SERVICE BULLETIN

NO. A6201-71-1

POWER PLANT - CORE COWLING - HOLD OPEN ROD
CLOCKING OF UNIVERSAL JOINT TO TELESCOPING
TUBE LOCKING LATCH

FIGURE 1 - A6201-2 END FITTING

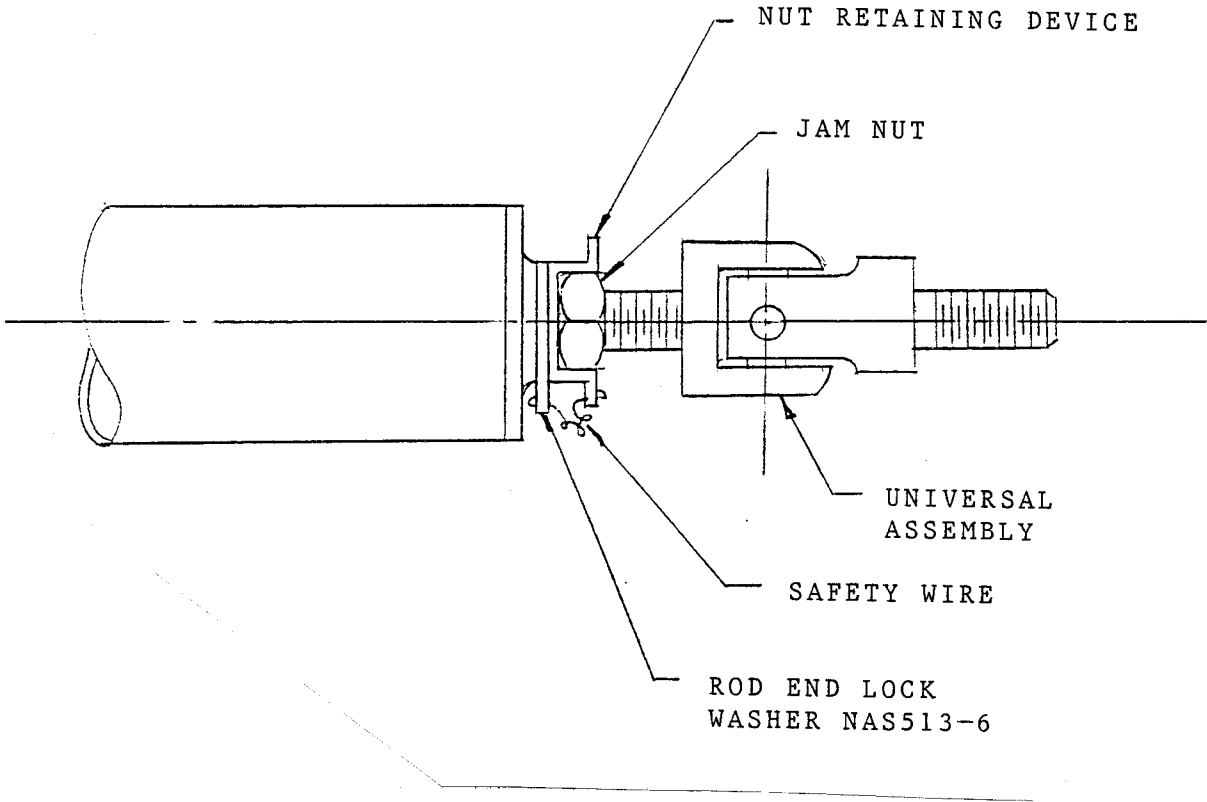
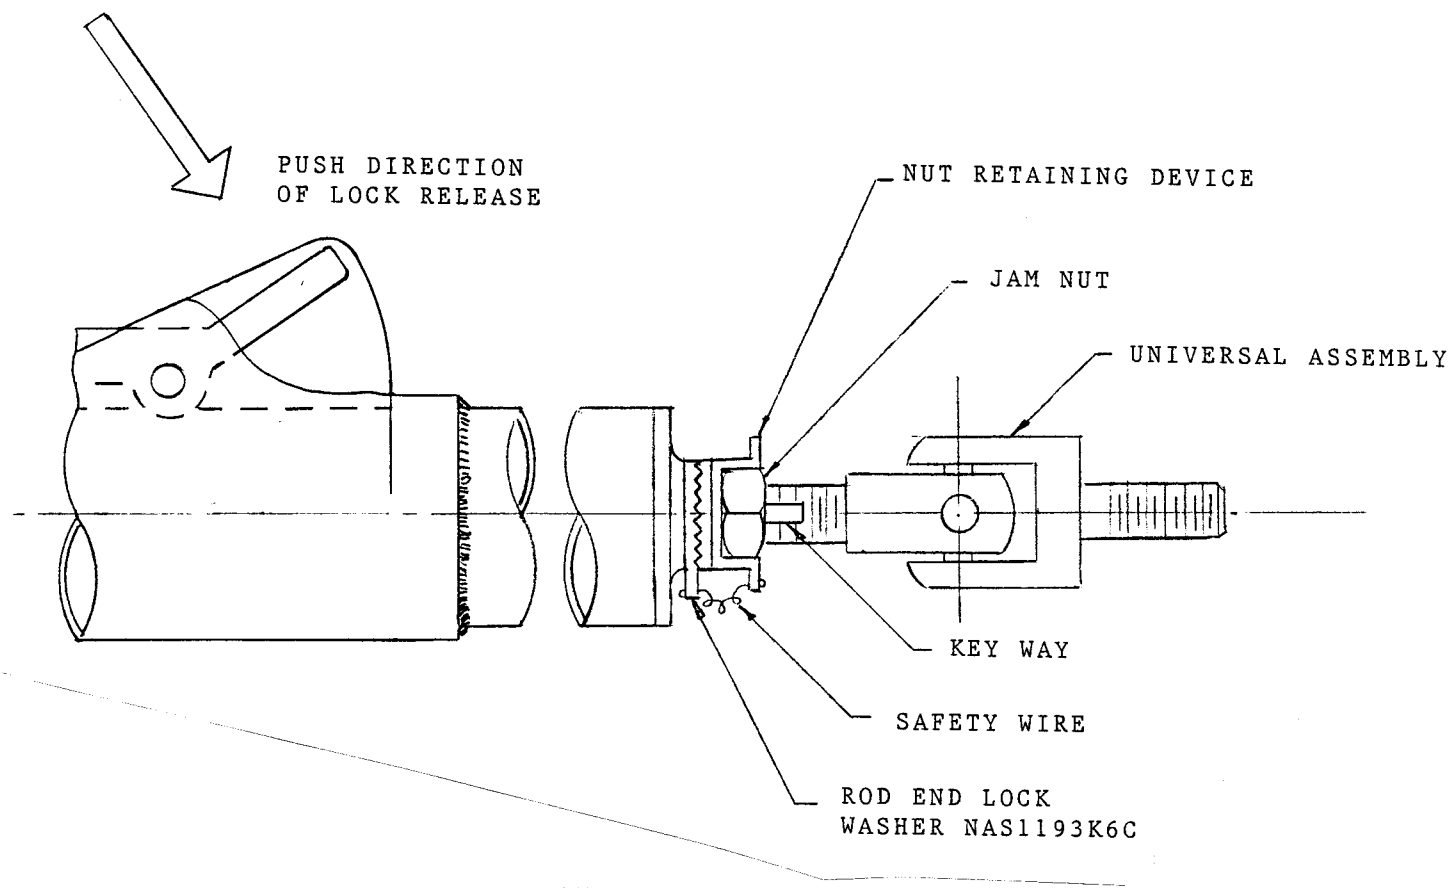
The incorporation of this Service Bulletin will prevent interference and chafing of the locking latch handle with other parts when the hold open rod is installed in the stow position.

This Service Bulletin provides detailed instructions required for all users to rework Norco part number A6201-2 to the A6201-3 configuration (Boeing specification part number S314T220-14 to -17 respectively). The rework is clocking the universal joint to the telescoping tube locking latch to insure that the locking latch handle will be positioned in the forward direction when hold open rod is installed, and in the stow position to prevent interference and chafing with other parts.

- A. Cut safety wire on rod end lock washer, part number NAS513-6, as shown in Figure 1.
- B. Loosen jam nut in nut retaining device and unscrew universal assembly from end of Strut Assembly.
- C. Discard rod end lock washer, part number NAS 513-6.
- D. Place new rod end lock washer, part number NAS1193K6C, on keyed shaft of universal as shown in Figure 2.
- E. Screw universal assembly into end of Strut Assembly. Keys on rod end lock washer should engage the slots of the end plug in the Strut Assembly. Tab on the inside diameter of the rod end lock washer should engage the keyway of the universal assembly.
- F. Adjust the orientation of the universal keyway so that it is rotated 90 degrees from the push direction of the lock release on the outer tube, as shown in Figure 2. Tighten the jam nut in the nut retaining device.

- G. Check that the length of the Strut Assembly is $27.50 \pm .06$ inches extended and locked under compressive load. The length should be measured from the center of the universal pivot to the center of the coupler opening. If necessary, readjust the length by repositioning the universal assembly.

- H. Safety wire the rod end lock washer to the nut retaining device with MS20995C32 safety wire.
- I. Clean area immediately following NORCO P/N A6201-2 by rubbing with wiper dampened with Aliphatic Naphtha, TT-N-95, or equivalent, until soil is removed. Do not allow solvent to evaporate. Avoid removing pretreatment or finish coating. After soil is removed, wipe the area dry with a clean dry wiper. Using rubber stamp letter size 1/8" to 3/16" and Alcosol or F-100 stamp pad ink, or equivalent, apply the letter "M" immediately following the dash number "-2". Clean stamp with naphtha, or equivalent, as required, for mark legibility and sharpness. Allow ink to dry at least ten minutes and overcoat with Bostik 683-3-2 or 683-3-9 or equivalent.
